Customer Report

Results of DDR Detective investigation on an early OCP system

Results from a Data Center visit in May of 2013 describe several JEDEC violations found on an early OCP Server. Customer was interested in deploying OCP based servers and wanted more information on the robustness of the design/manufacturing and configuration.

Figure 1: The DDR3 Detective Setup for the AMD OCP RoadRunner System

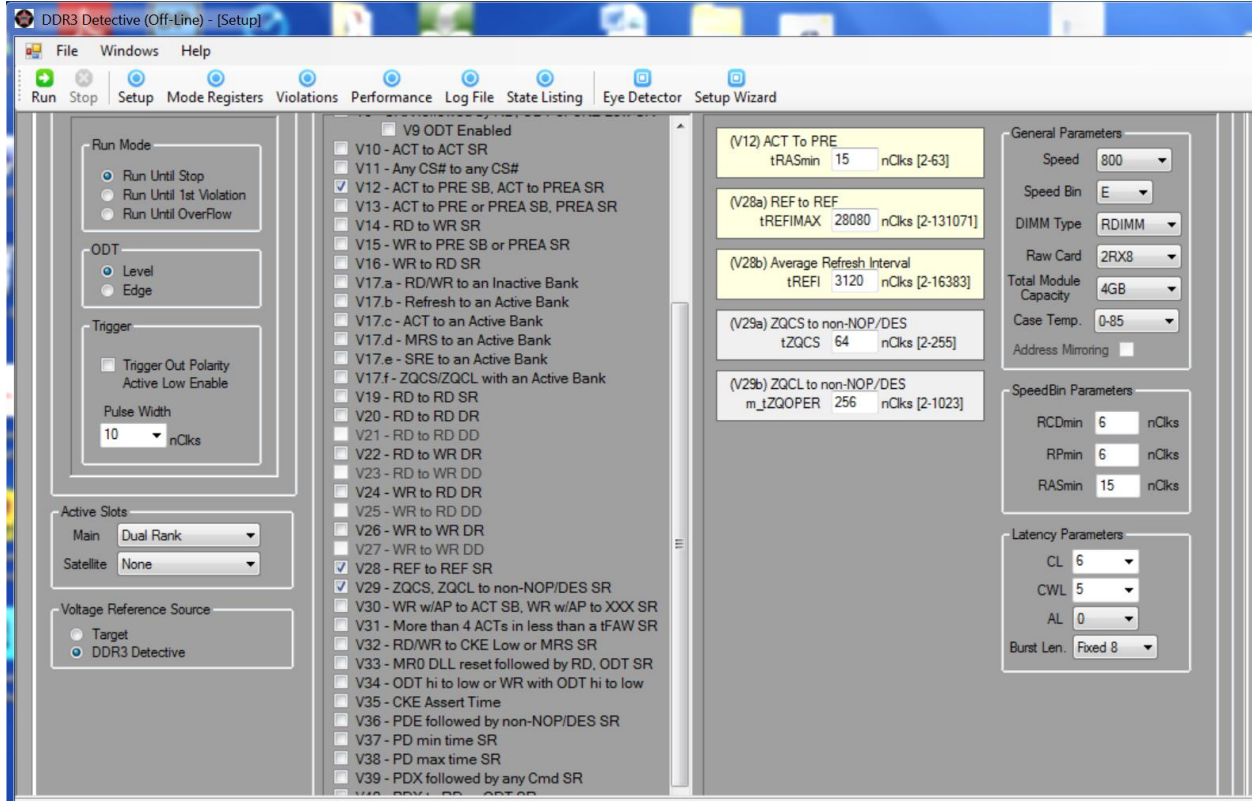
1600), the size of the DIMMs and the Speed Bin and latency parameters. The latency parameters are picked up by monitoring the MRS transactions at boot time. The Speed Bin parameters are derived from those numbers and the specification. More details on the speed bin parameters can be seen on page 173 of the DDR3 JEDEC spec. I have checked off the violations we found.

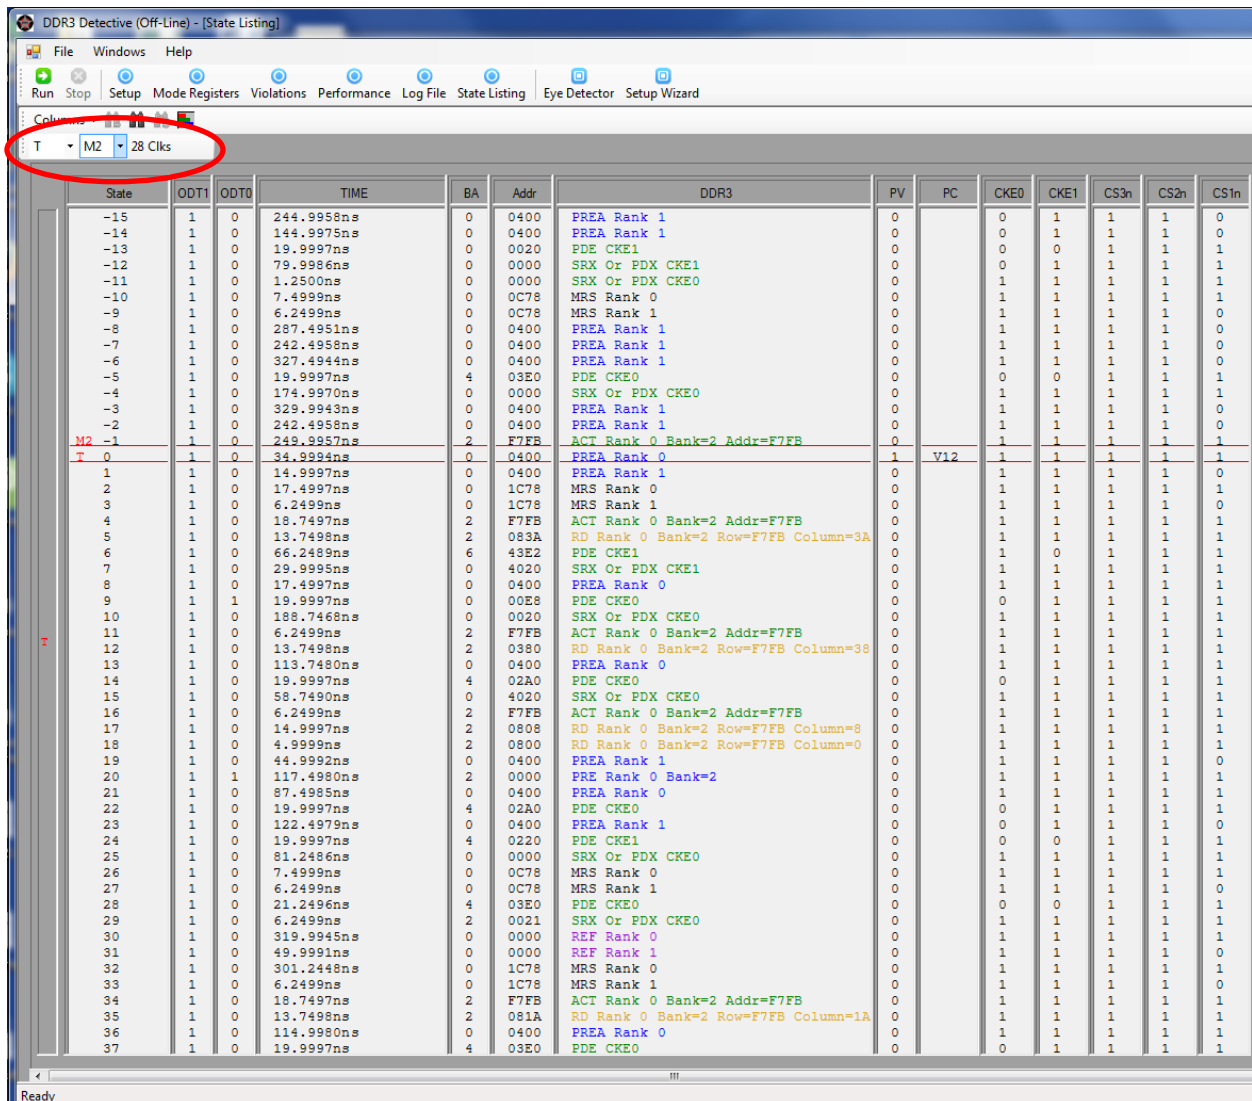
This is a violation that we saw at the OCP workshop and AMD said was a BIOS setting issue. Here it is again on the system we tested at your data center. This time the numbers are a bit different because this system was running at 1600 and the system at the OCP workshop was running at 800. However the violation is the same, 1 clock cycle.

Based the settings 29 clocks is the closest these two commands can ever appear on the bus. We saw this violated thousands of times. Here is the trace that shows one such violation. Note M2 to T measures 28 clocks and the violation is 29. So these two commands are one clock period too close together.
